ORE - TRAFFIC: January 2026 Proposed PIS & SCD's Updates Summary

Each SCD is bookmarked in this document for easier navigation to drawing of interest

MT-120.00 MODEL: Sheet 2 of 2 PAPER SIZE: 34x42 (in.) DATE: 6/15/2024 TIME: 3:23:50 PM USER: kflant pw:\ohiodot-pw.bentley.com\ohiodot-pw-02\Documents\03_Standards\PLS_SCD\Traffic Control\Working Folder\2024\07_July\SCD\MT-120.00\MT-120.00_2024-07-19.dgn

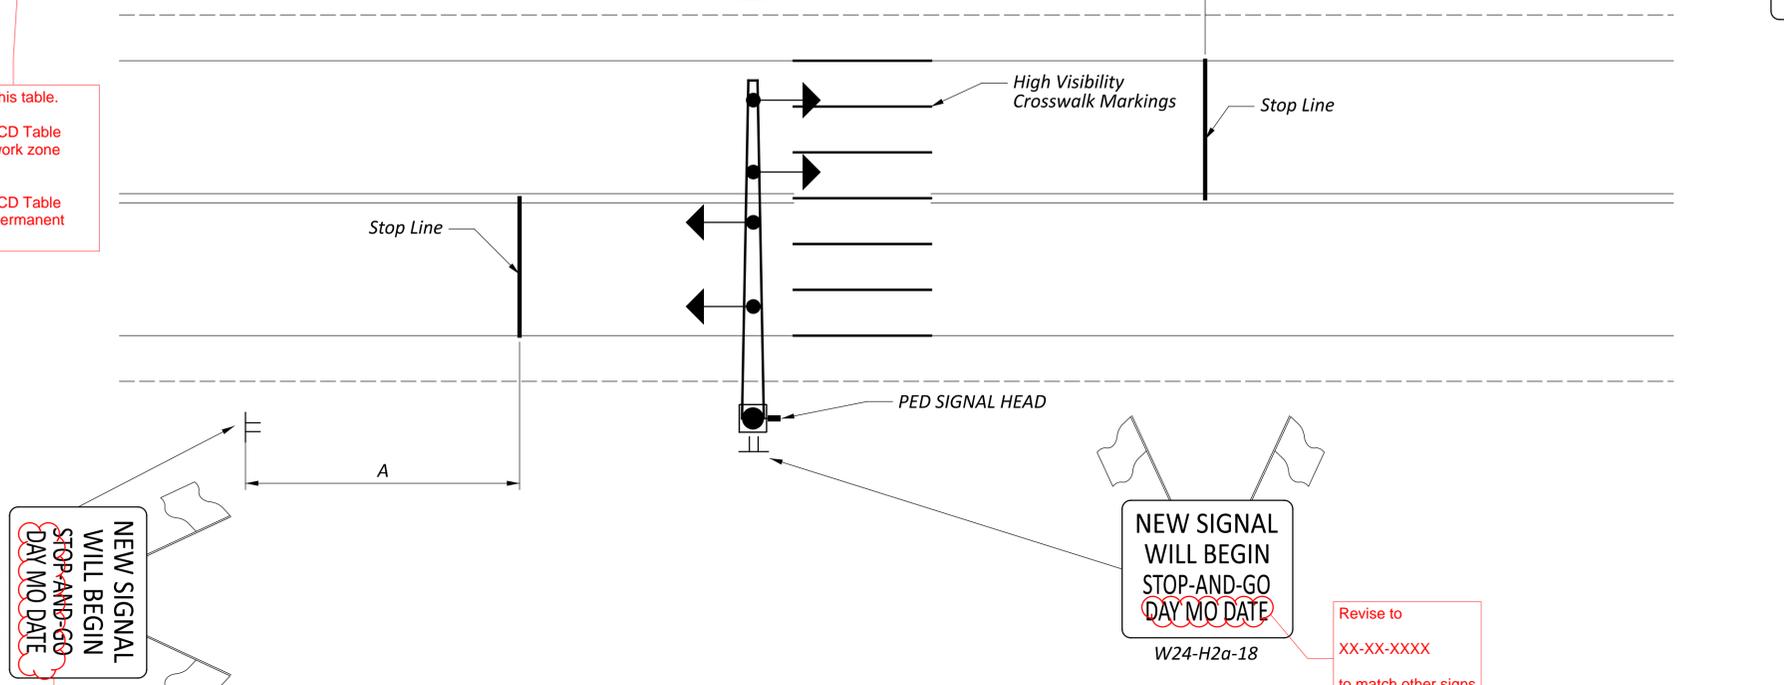
Remove this table. Use MUTCD Table 6B-1 for work zone signs. Use MUTCD Table 2C-3 for permanent signs.

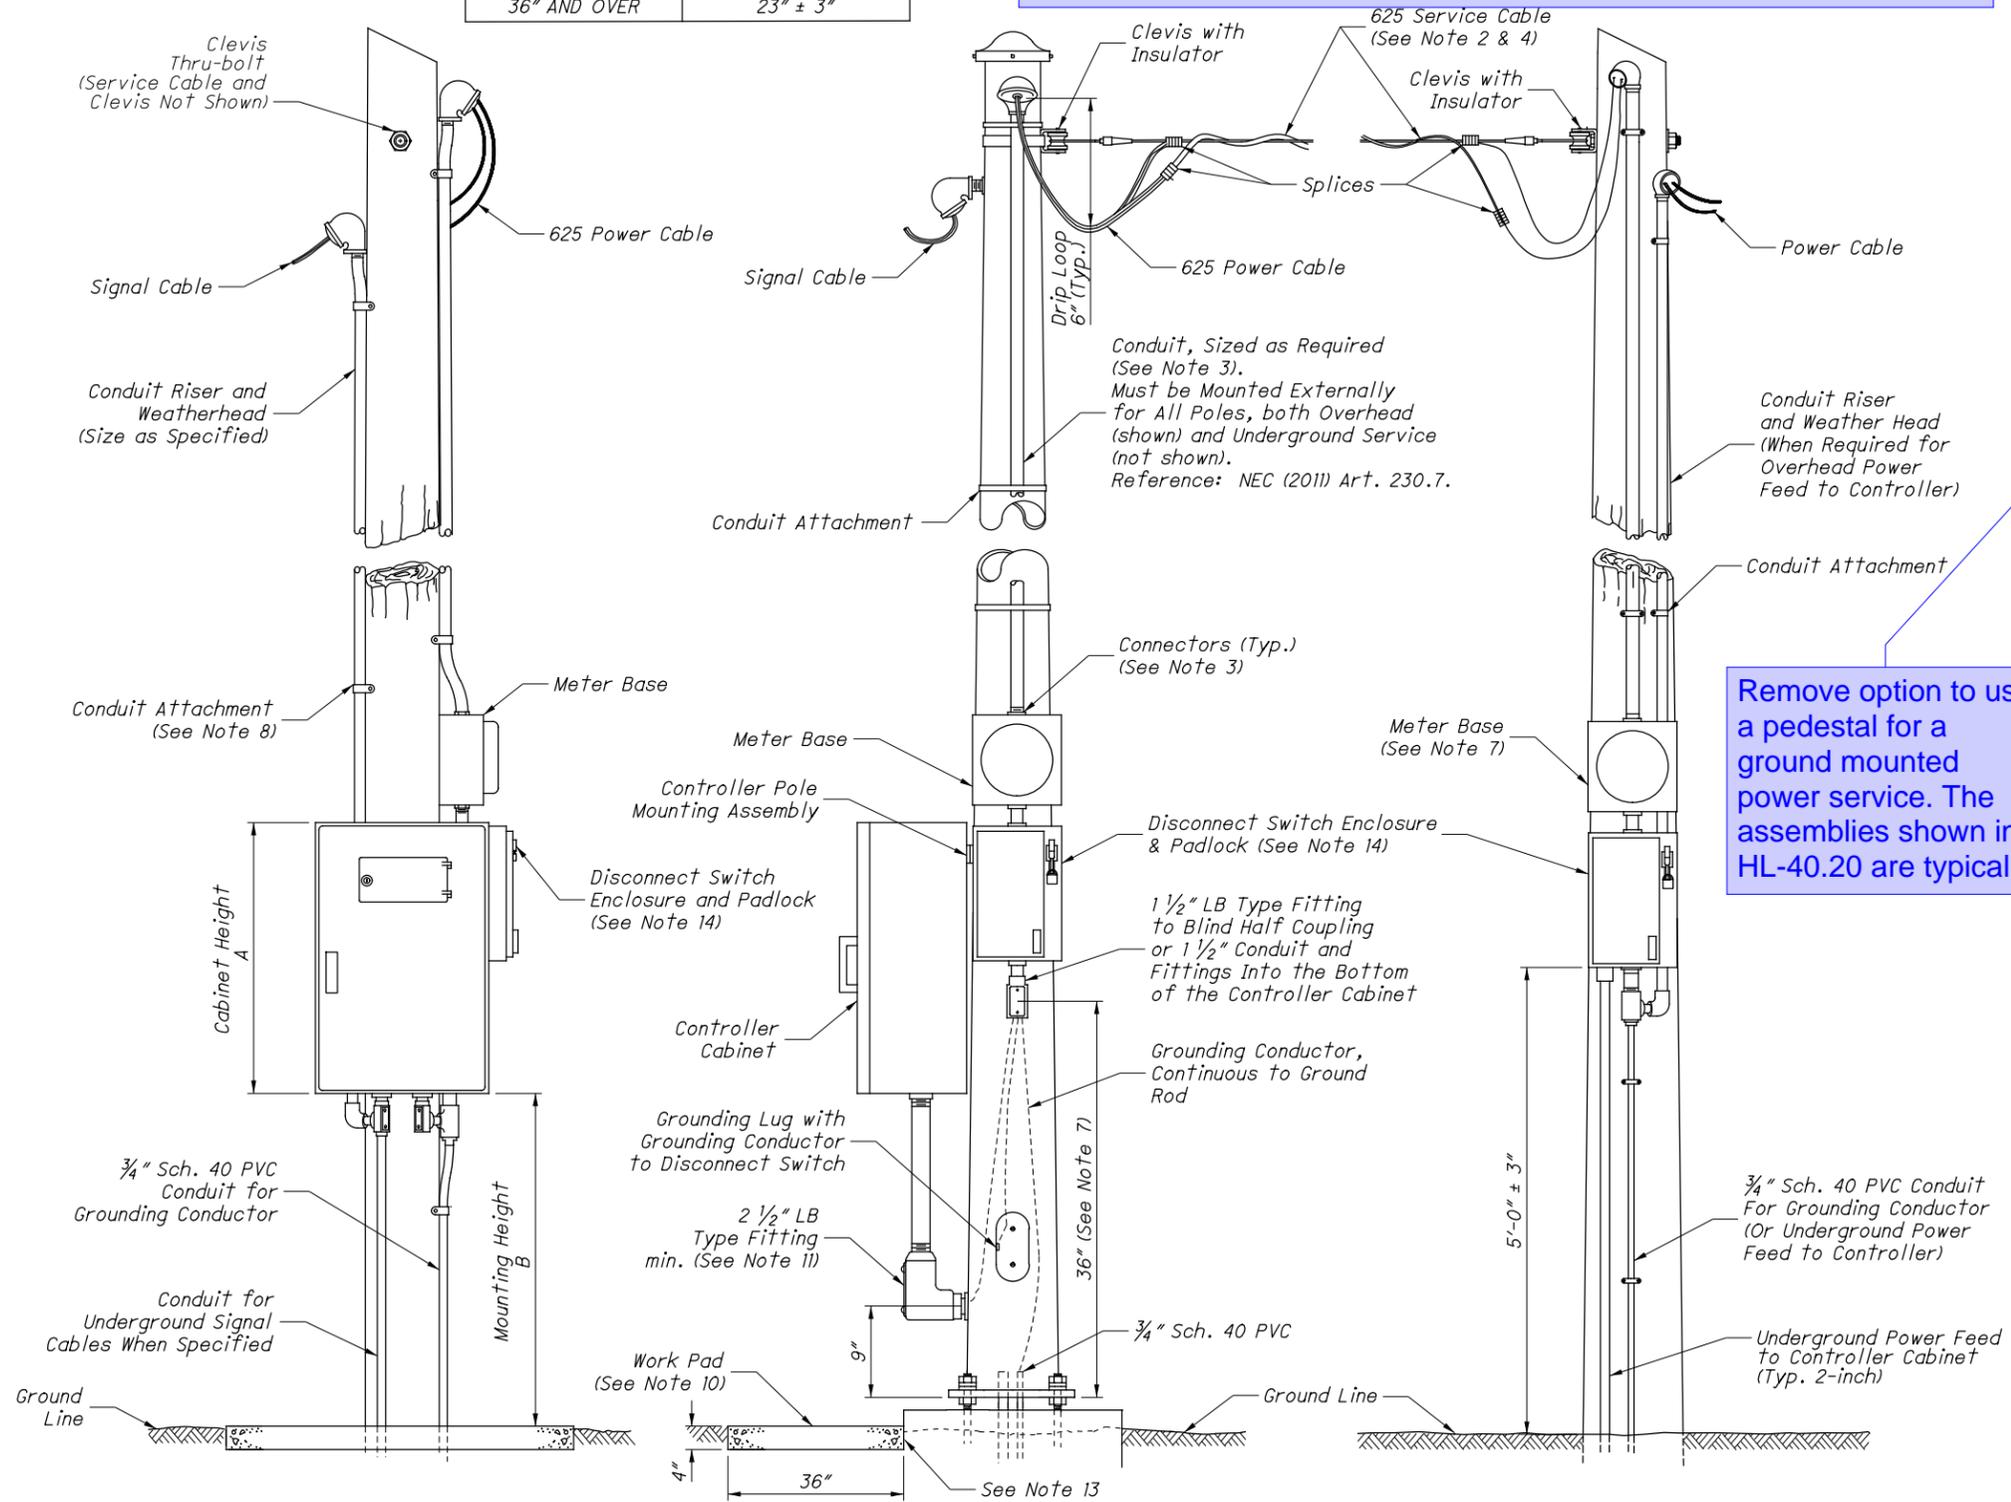
Reason: The power industry is moving towards CT metering for 480V services, which will not fit easily on a pole. This matches requirements that exist in HL-40.20 and that are being added this cycle to ITS-15.11.

Remove option to use a pedestal for a ground mounted power service. The assemblies shown in HL-40.20 are typical.

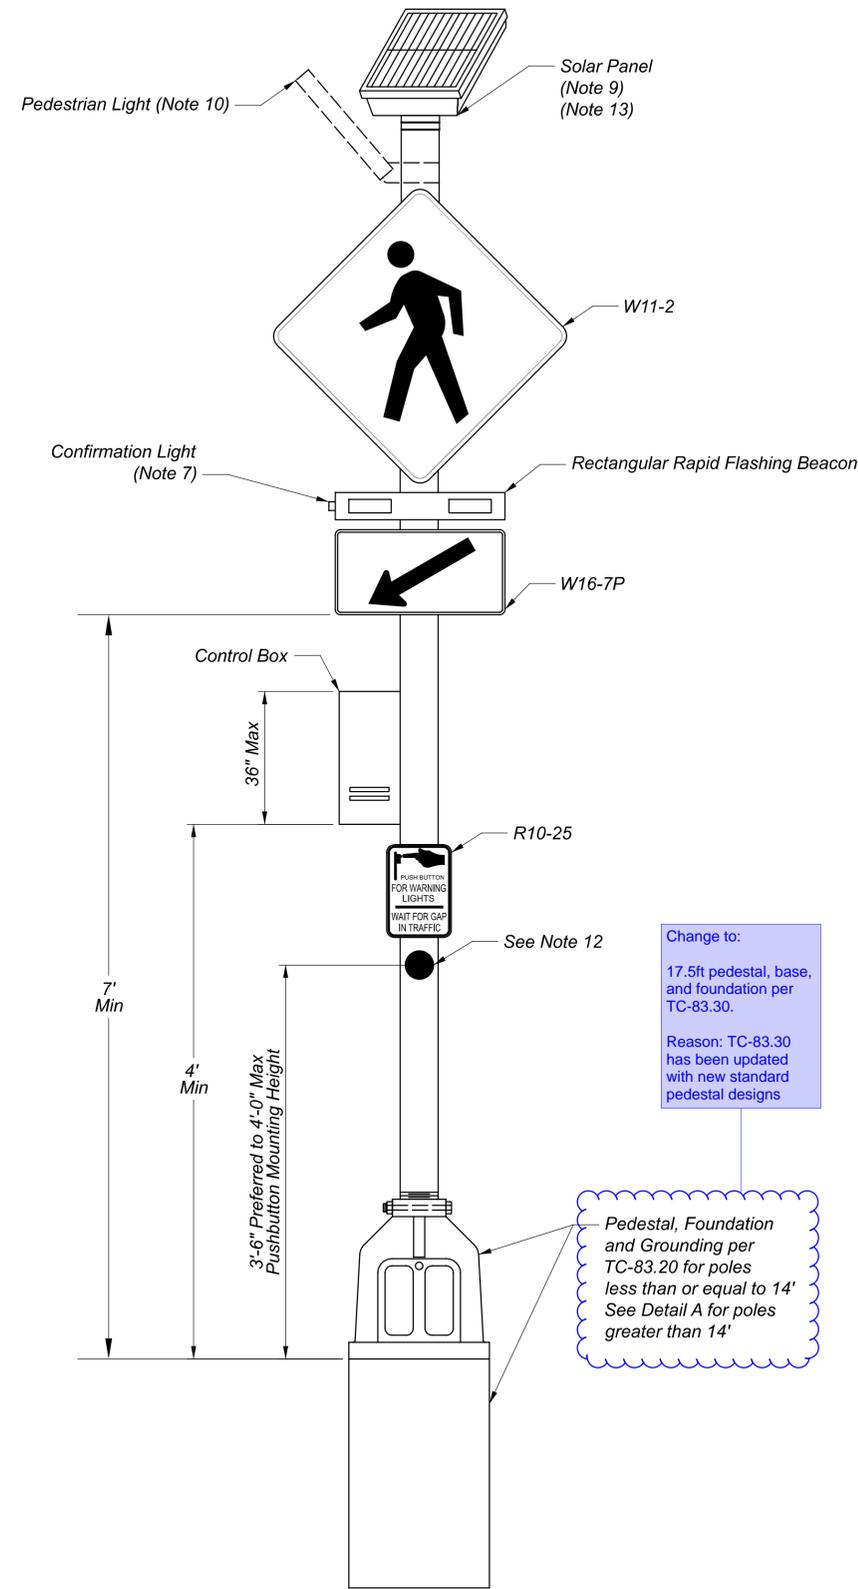
Remove notes for wood poles

SOLAR POWERED RRFB

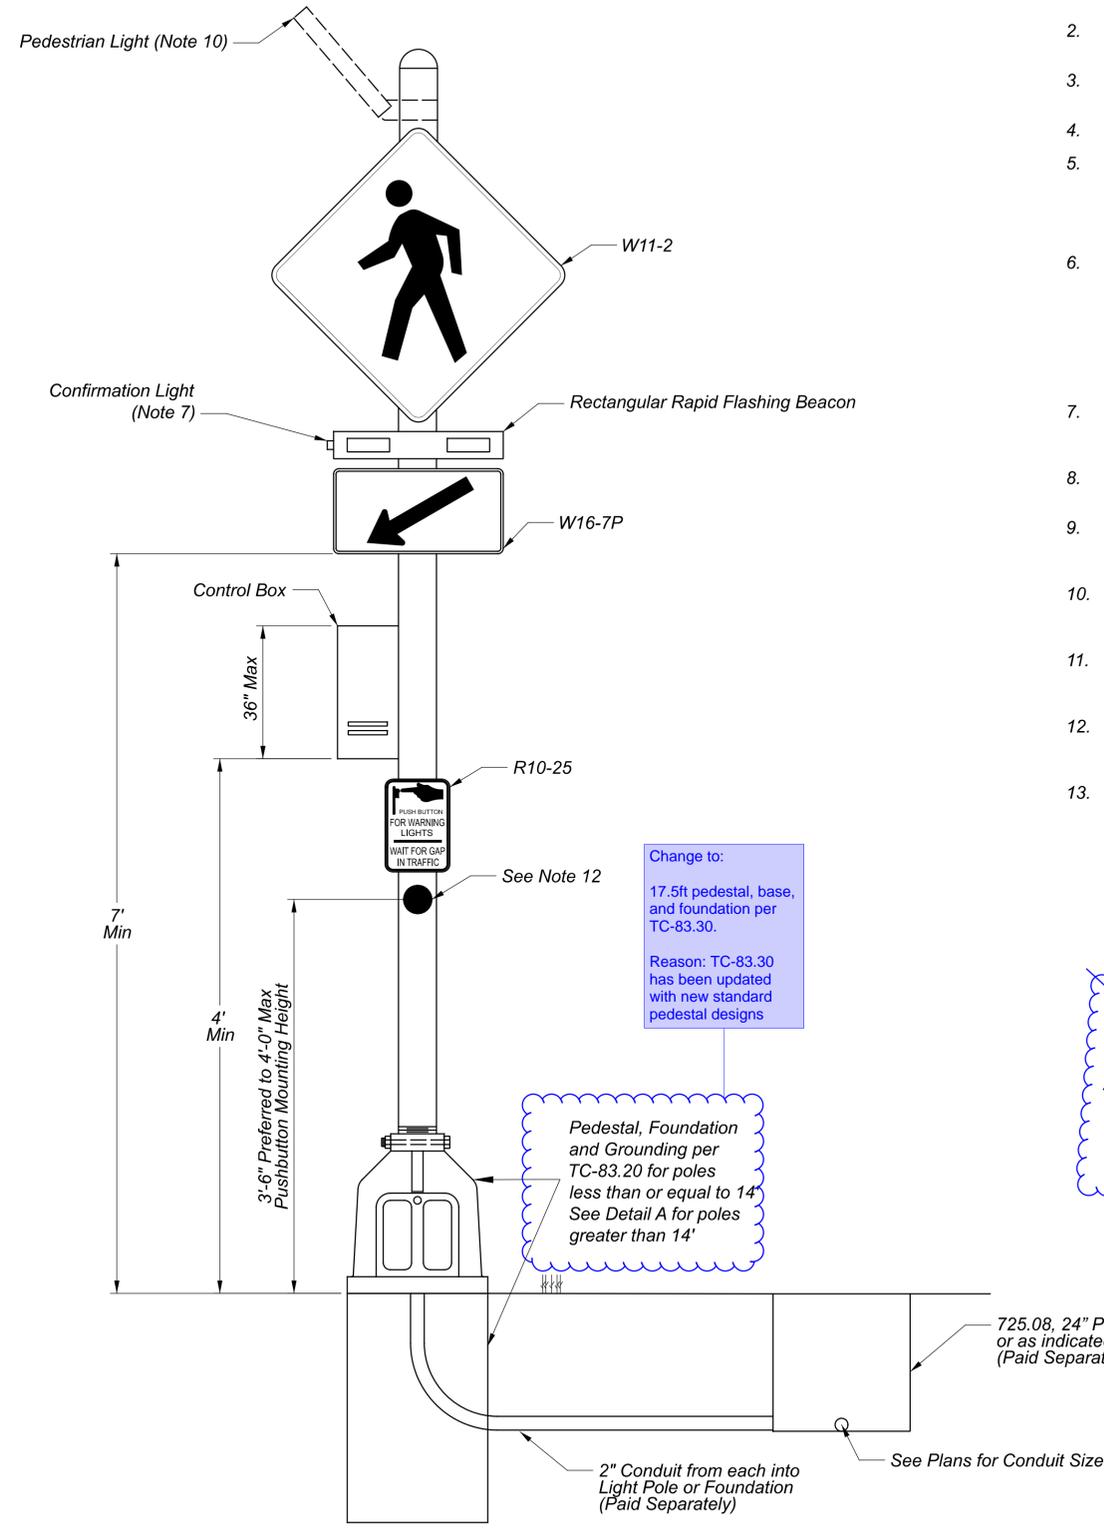
Change to:
17.5ft pedestal, base, and foundation per TC-83.30.
Reason: TC-83.30 has been updated with new standard pedestal designs

Change to:
17.5ft pedestal, base, and foundation per TC-83.30.
Reason: TC-83.30 has been updated with new standard pedestal designs

Remove detail. Use a 17.5ft pedestal per TC-83.30 for all RRFBs
